TN ERFO FS CHRKE804 2020-2(1)

Amendment No. 0002
Project TN ERFO FS CHRKE804 2020-2(1)
Cherokee National Forest
Solicitation: 693C73-26-B-000011

The purpose of this Amendment is to:

AMENDMENT NO.2	PROJECT	SHEET NUMBER
	TN ERFO FS CHRKE804 2020-2(1)	A04

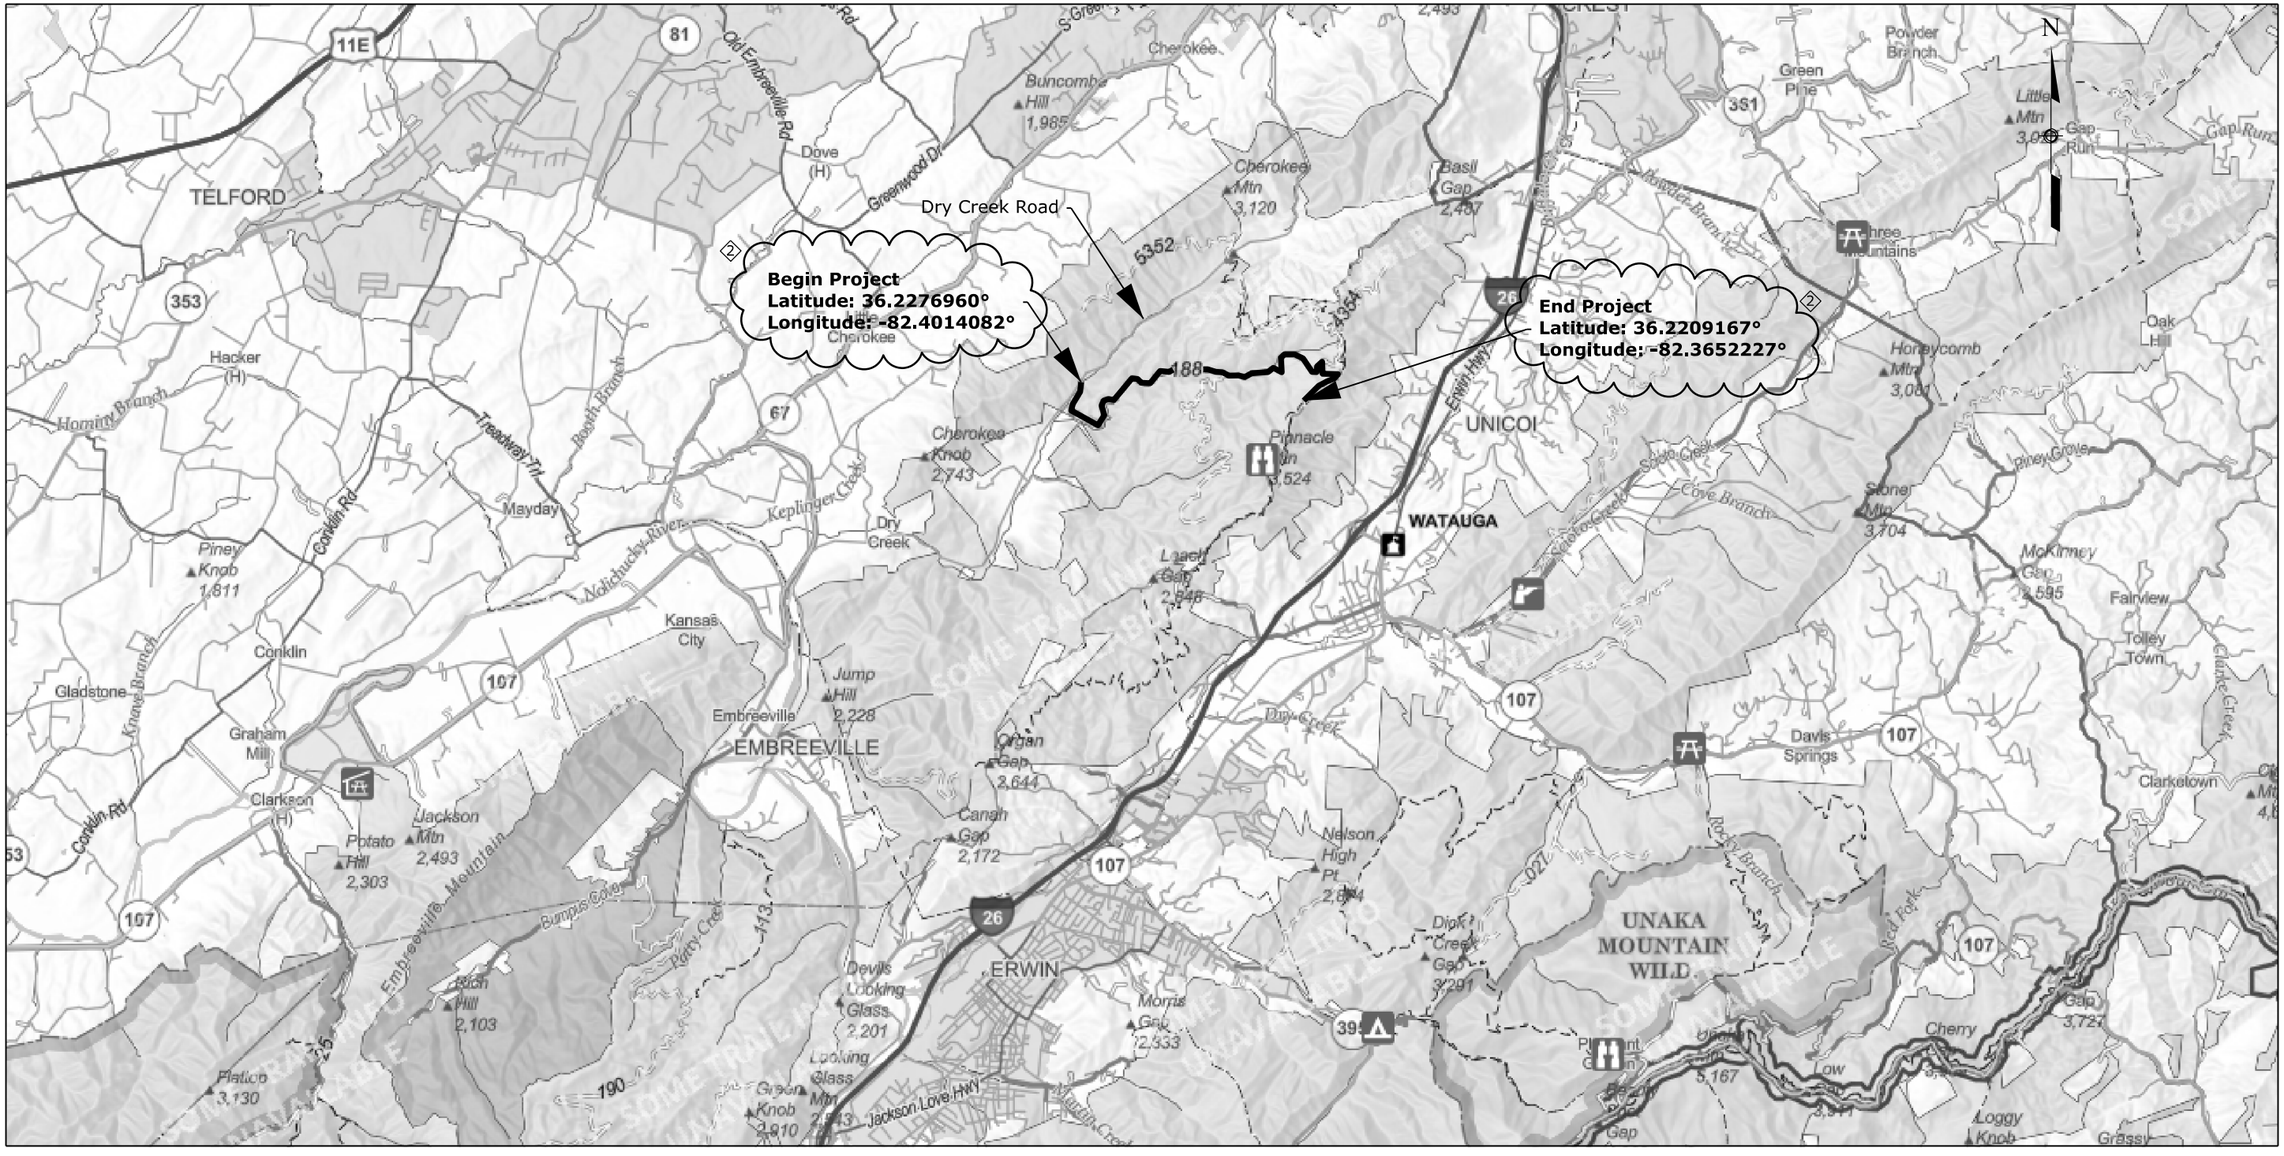
NO.	DATE	BY	REVISIONS
2	06/15/26	JMF	AMD #2 - Updated Latitude/Longitude callouts.

AMENDMENT NO.2	PROJECT	SHEET NUMBER
	TN ERFO FS CHRKE804 2020-2(1)	A05

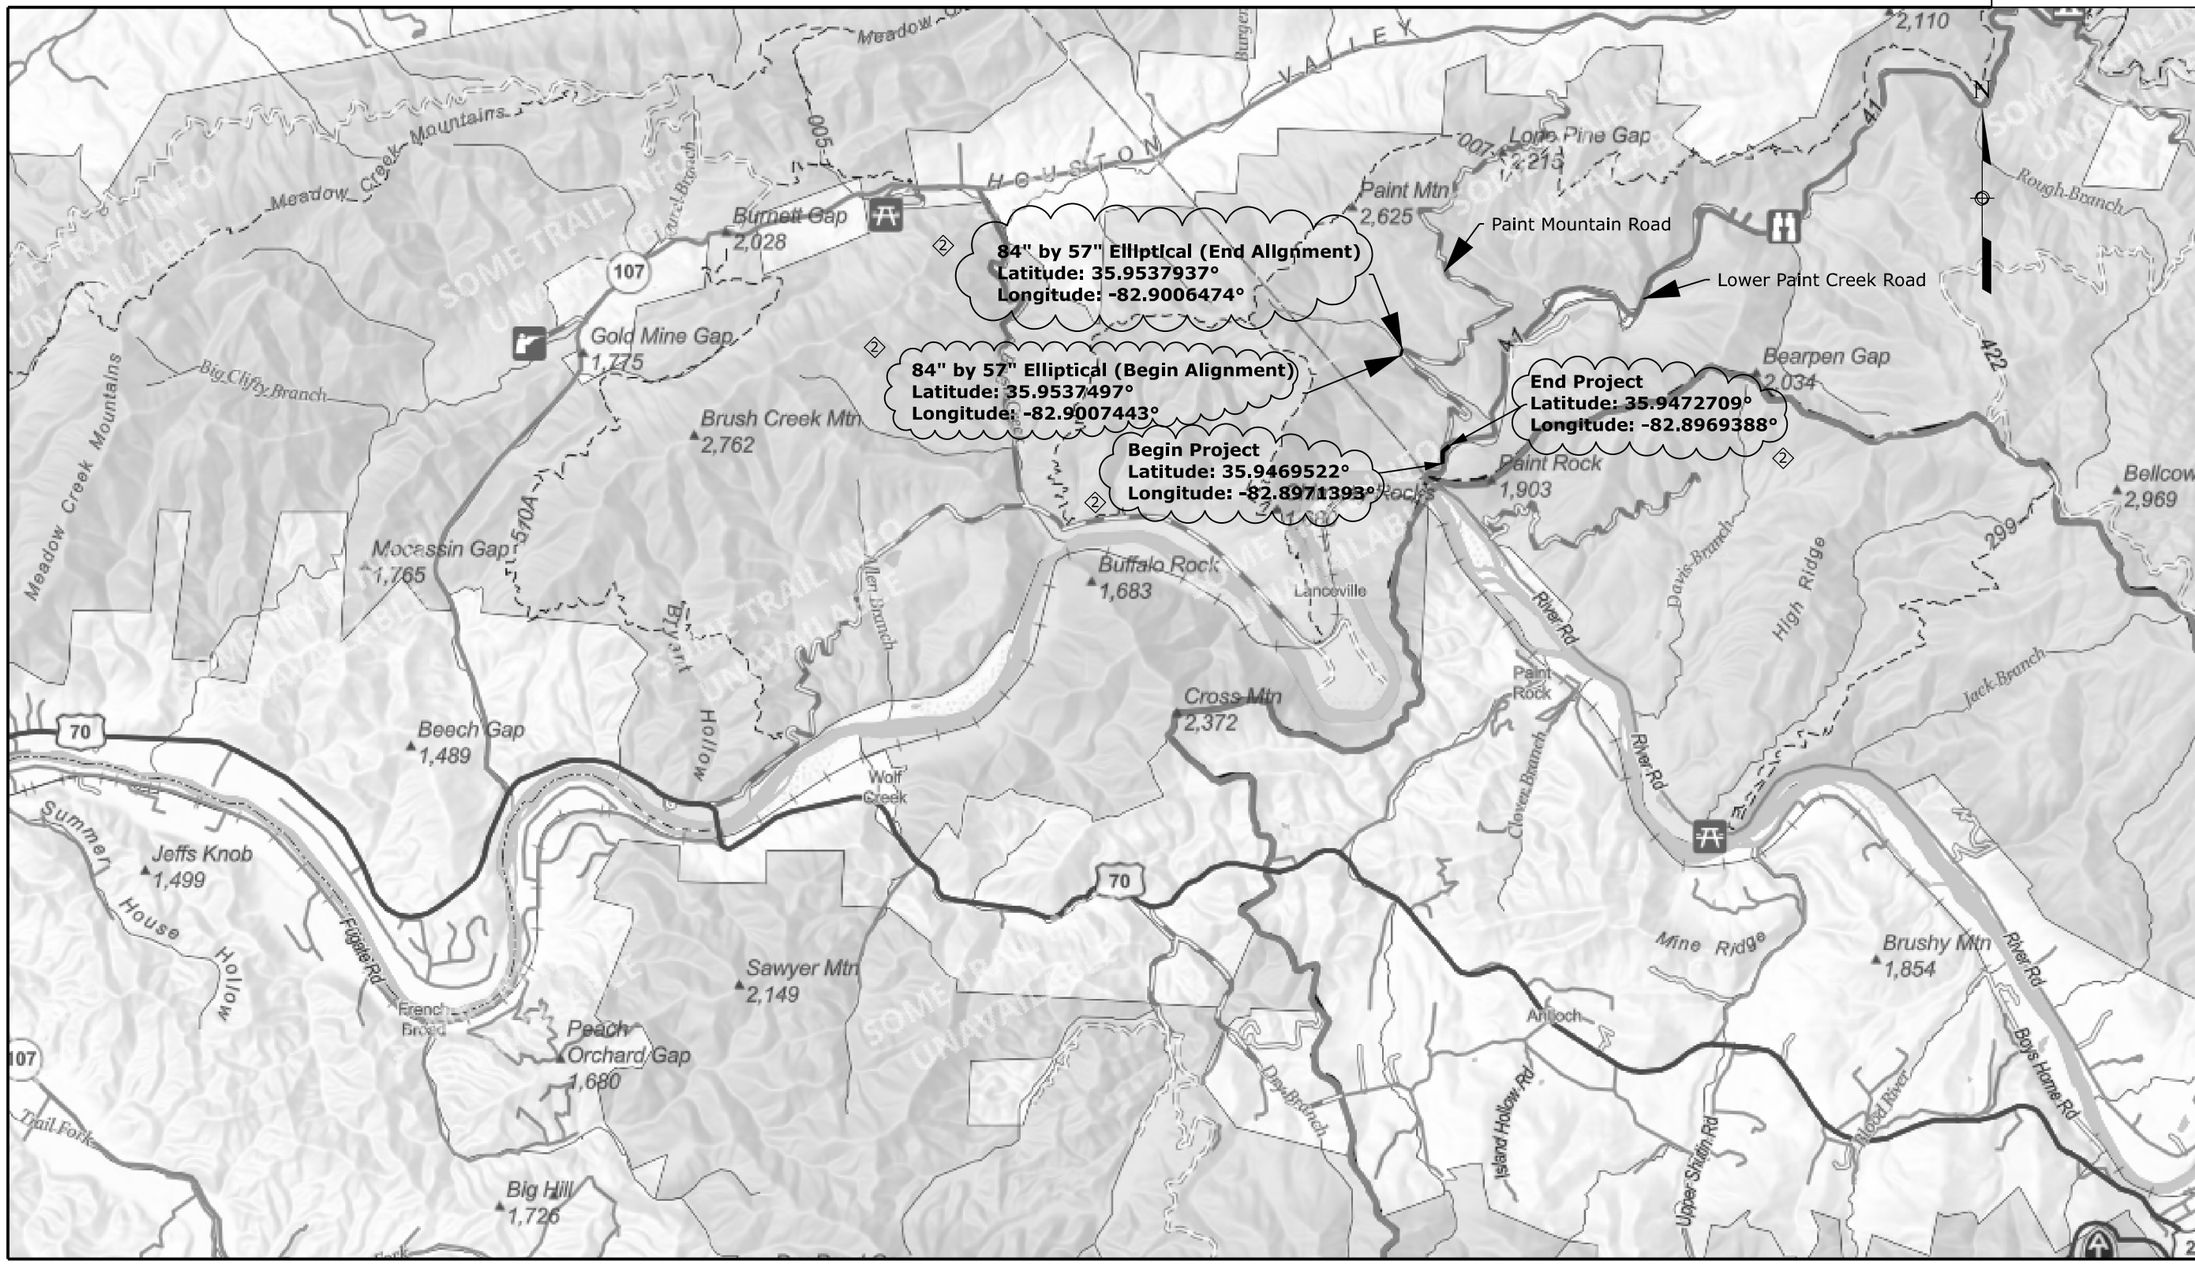
NO.	DATE	BY	REVISIONS
2	06/15/26	JMF	AMD #2 - Updated Latitude/Longitude callouts.

AMENDMENT NO.2	PROJECT	SHEET NUMBER
	TN ERFO FS CHRKE804 2020-2(1)	A06

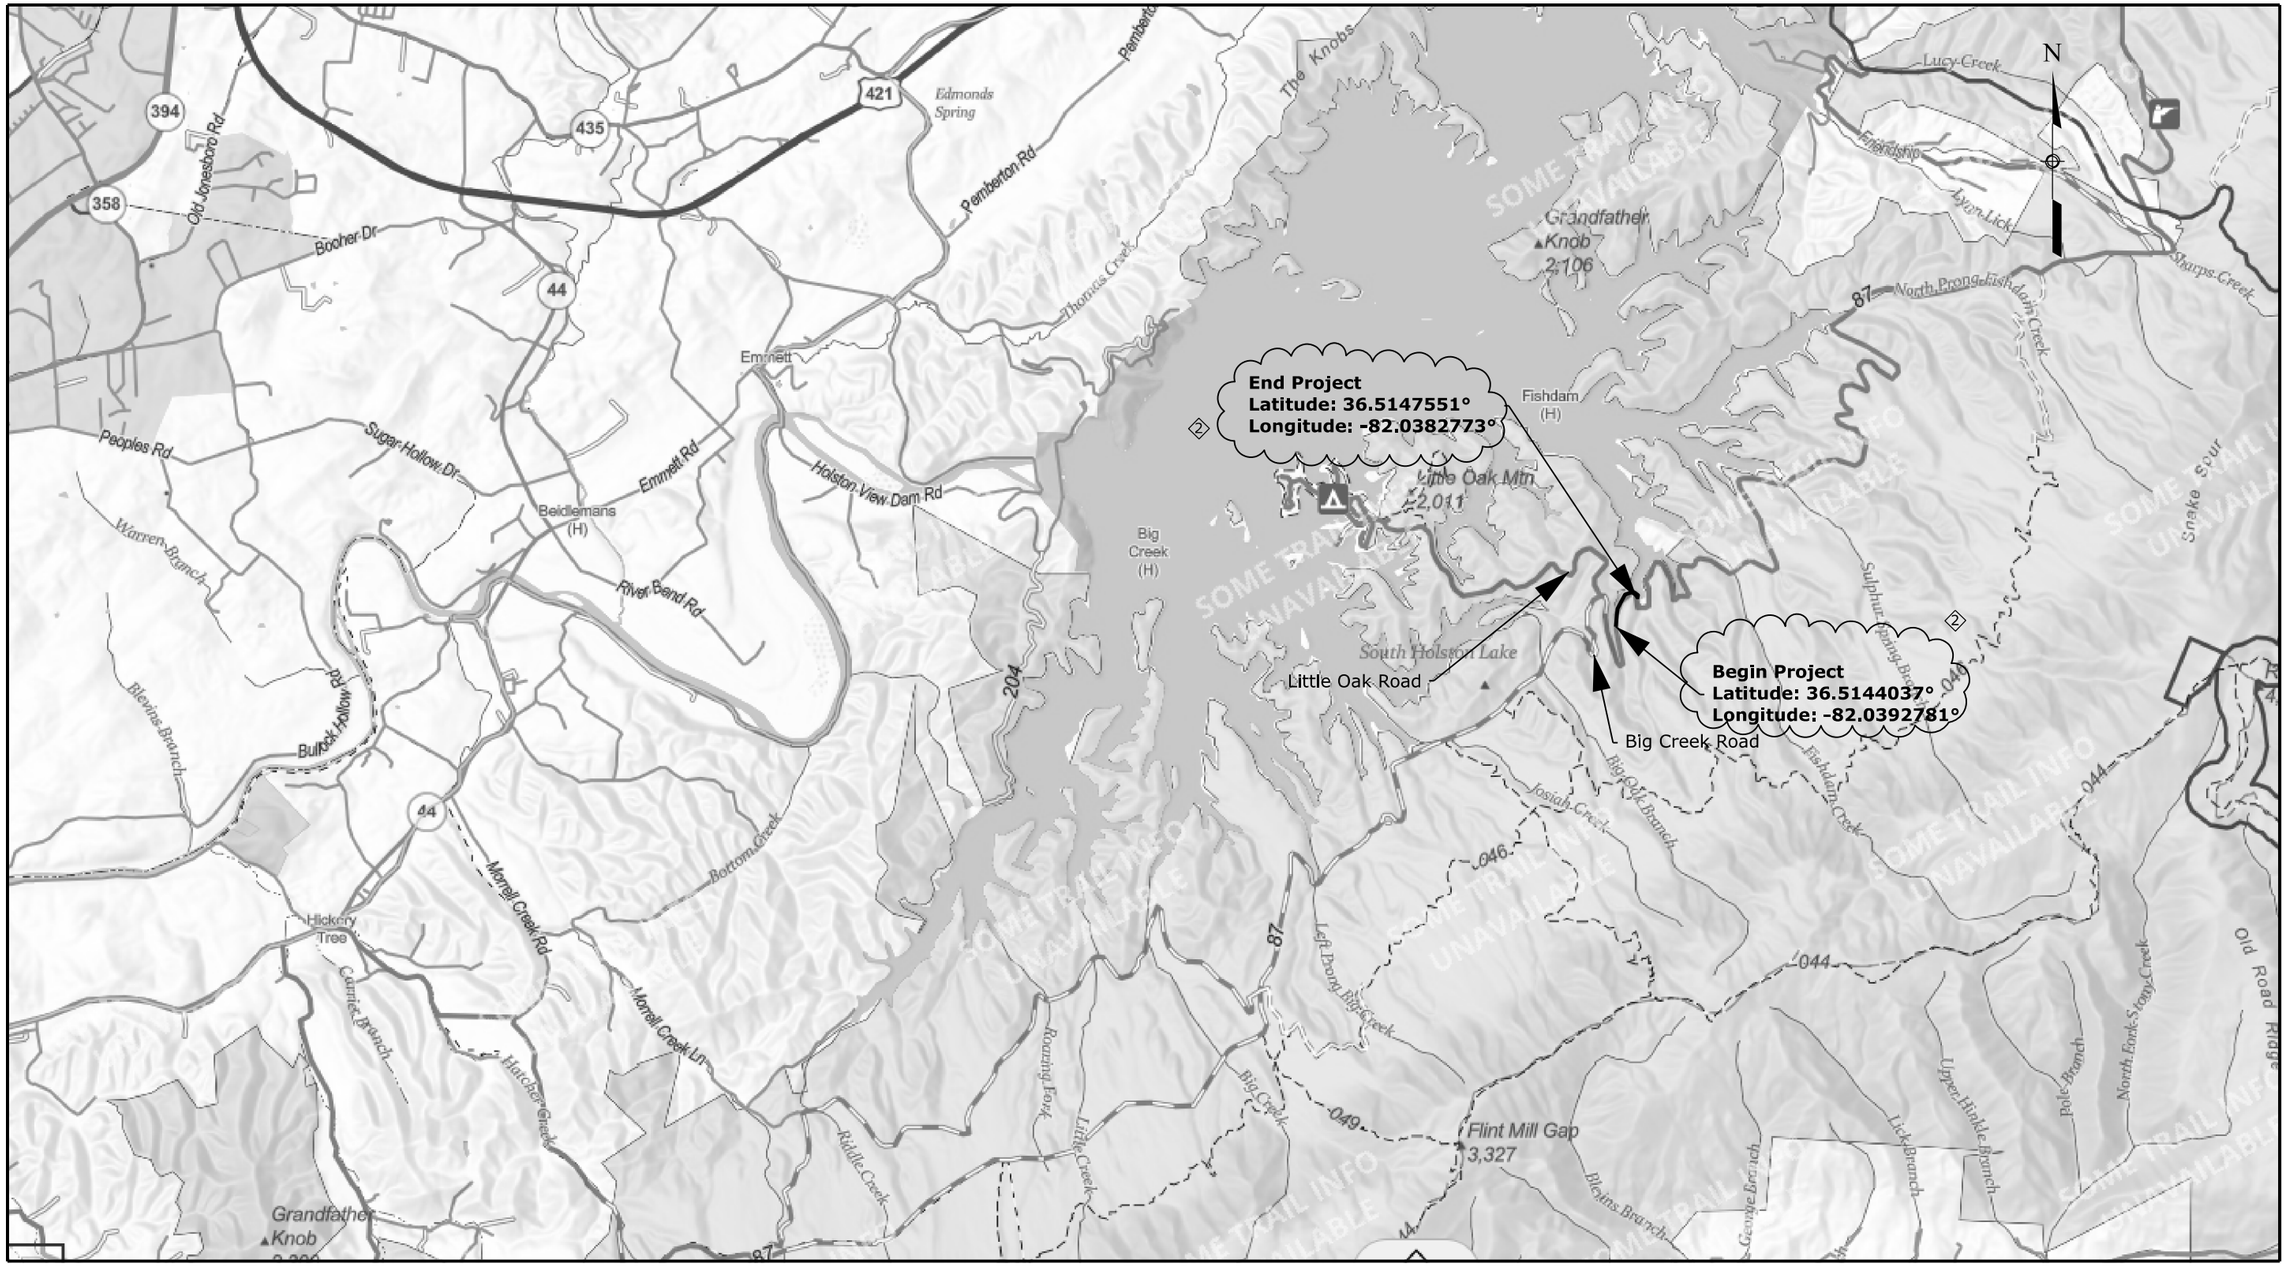
NO.	DATE	BY	REVISIONS
2	06/15/26	JMF	AMD #2 - Updated Latitude/Longitude callouts.

TYPICAL SECTION
PAVEMENT RESTORATION AT MSE WALL

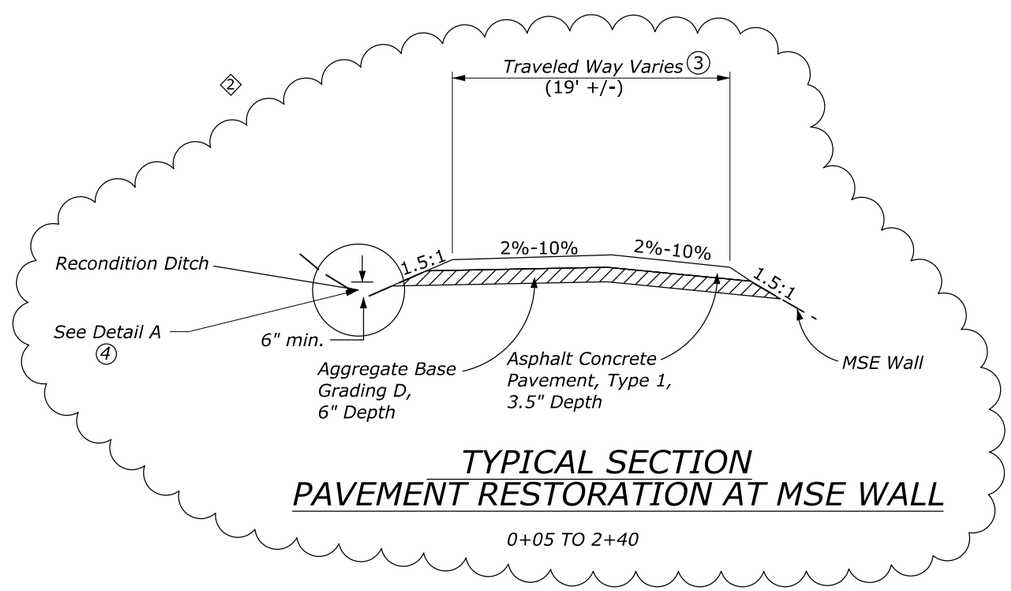
8. Drawing D12, Flatwoods Road, MP 5.78, shows installing a MSE wall. The roadway in this area is existing asphalt paving. In order to install the MSE wall, the roadway will have to be excavated, and the asphalt will be removed. There are currently no line items for asphalt pavement repair. Please Advise if this needs to be added to the price schedules? **Response: Asphalt pavement repair details and pay items have been added.**

NO.	DATE	BY	REVISIONS
②	06/15/26	JMF	AMD #2 - Added typical section.

GENERALIZED CELLULAR CONFINEMENT SYSTEM SECTION

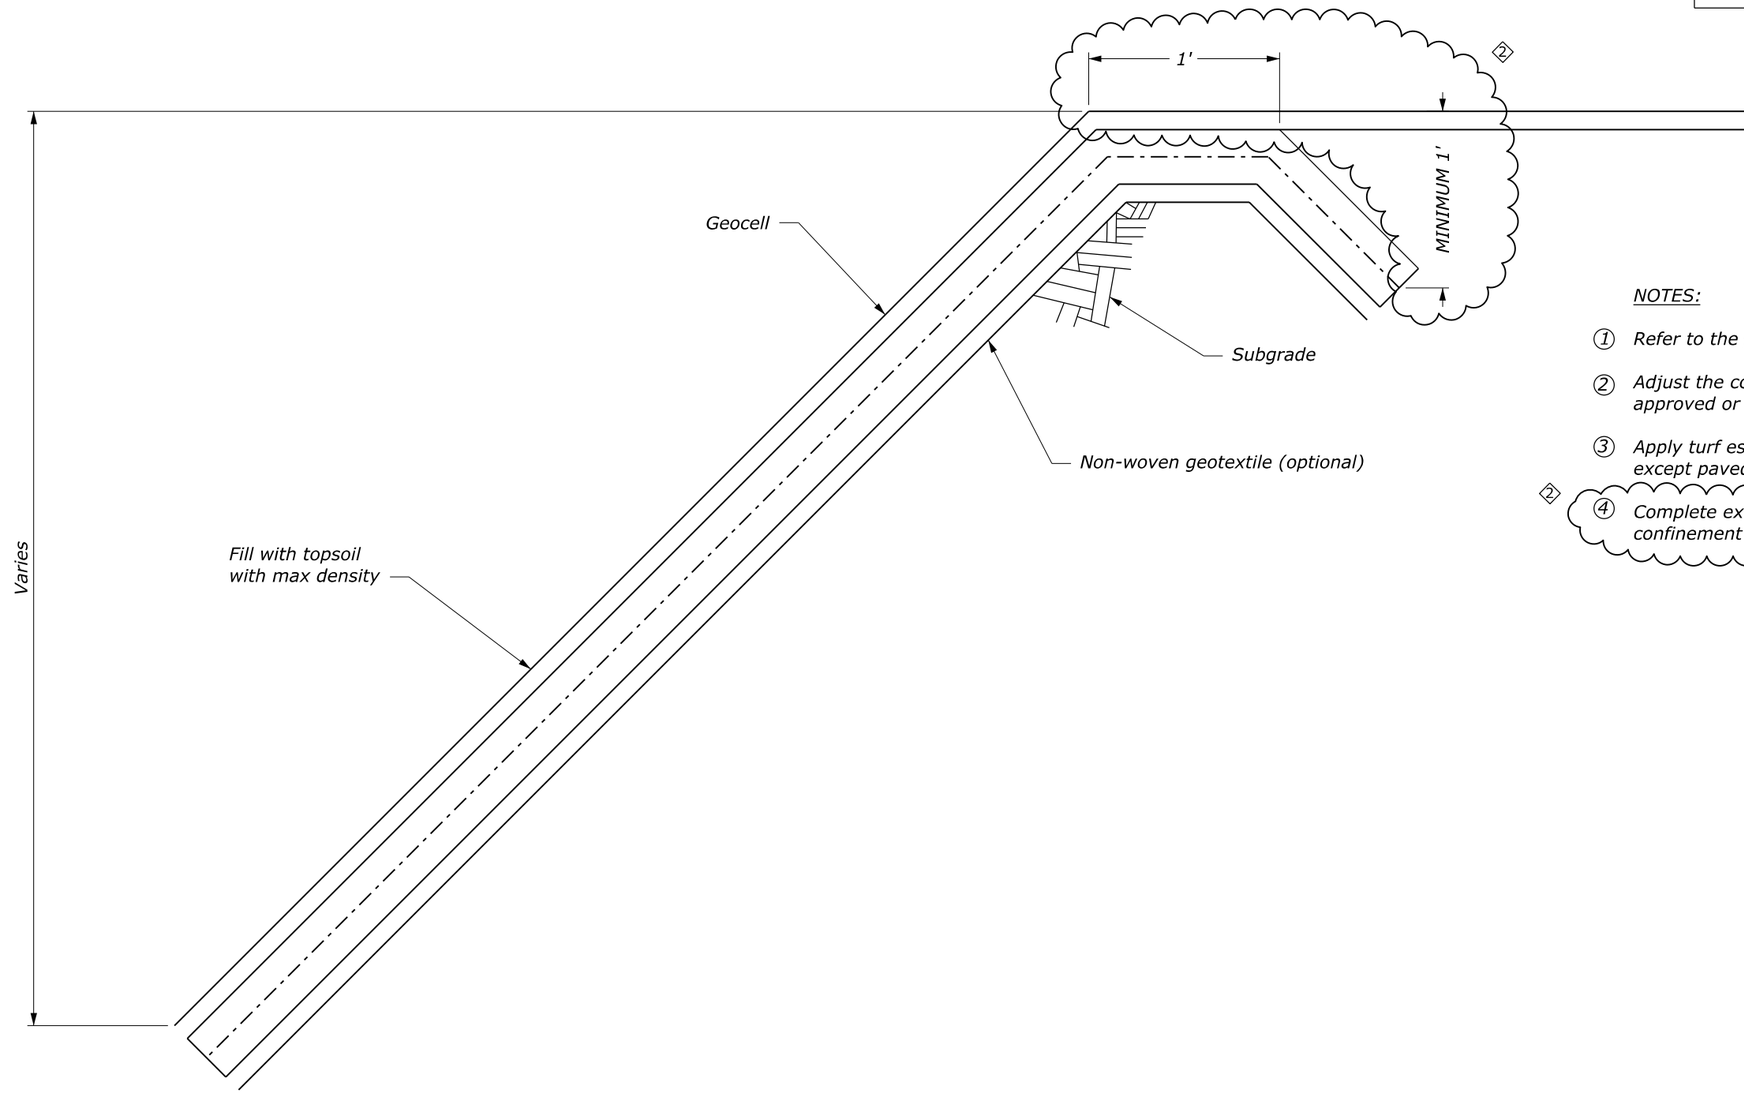
9. Drawing M13, Flatwoods Road, MP 5.78, shows installing a Cellular Confinement System for Slope Stabilization. This drawing also outlines the LOD (limits of disturbance). Drawing B03 shows a typical section for the Cellular Confinement System, which shows the top section turned under, and what we assume is buried once trenched in the ground. The LOD doesn't allow enough room to allow this to happen. Are we allowed to clear additional to make this work? If so, how far back are we allowed to clear back? Also, the grade is too steep to access equipment. Will the contractor be allowed to gain access from another location that is safer to gain access to the top of the cellular construction area? **Response: Sheet B03 has been updated to provide the dimensions for the limits of disturbance. Additional access points must be approved by the CO prior to bringing work.**

12. Can EFL provide more information regarding the cellular confinement system? Sheet 18 has very limited information. Section sheets in the back of the plan set seem to show anchorage devices, but no details are provided in the plans. After visiting the site it would seem that re-grading the washed out area prior to installing geo confinement would be prudent, but those details are unclear. The types of geocell that would be acceptable is not clear. Is the expectation that the contractor will design this system? **Response: See FP-24 Section 629 for additional requirements.**

NO.	DATE	BY	REVISIONS
②	06/15/26	JMF	AMD #2 - Added dimensions and note.

1. Refer to the geotechnical report for site conditions.
2. Adjust the construction limits to fit field conditions as approved or directed by the CO.
3. Apply turf establishment to all disturbed area except paved surfaces, traveled way, or rock face.
4. ② Complete extents inclusive of anchoring for cellular confinement system indicated by hatching on plans.
